Site Plan Review and Appearance Board

Meeting: November 13, 2019	File No.: 2019-256-SPF-SPR-CLIII (Waiver)	Application Name: Pierre Delray Phase 1 (SunTrust Bank)
----------------------------	---	---

302 E. Atlantic Avenue
Pierre Delray I (SunTrust Bank)

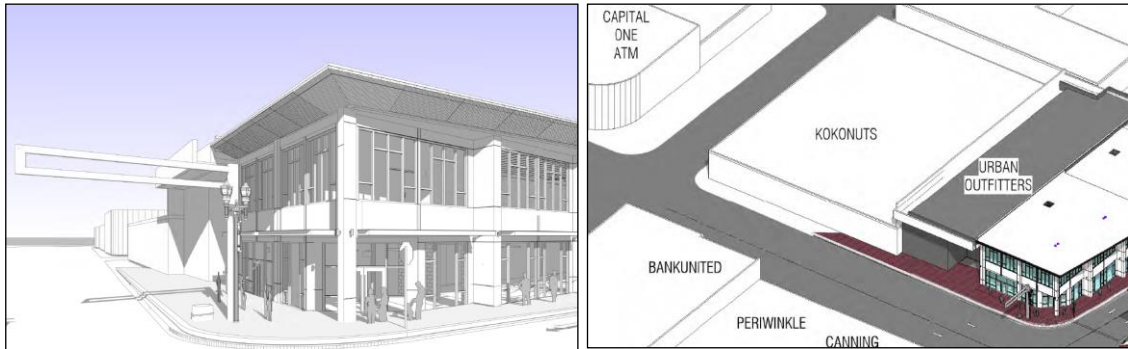
The waiver requested is for the reduction to the minimum required storefront setback from 10' to 7-10". The reduction will allow for the expansion of the ground floor retail space to replace the existing arcade area. The

waiver requested will not degrade the pedestrian experience along a Primary Street as the design includes a 15' required streetscape area along Atlantic Avenue. The Streetscape area provided incorporates a 4' curb zone, 6' pedestrian clear zone, and a 5' remaining setback. The 6' pedestrian clear zone will provide adequate two-way travel spaces for walking traffic. The 5' remaining front setback provided allows for outdoor dining area, removeable planters, or extended sidewalk area which aid in providing function and aesthetics for pedestrians. The building design includes shading techniques such as ground floor storefront awnings, column reveals and a cantilever parapet roof that helps cool surface temperatures for pedestrians. Lastly, the waiver requested does not result in the creation of large expanse walls. The proposed storefront design exceeds the minimum 80% required openings which creates a transparent view of the interior retail spaces and attracts pedestrians to the ground floor.
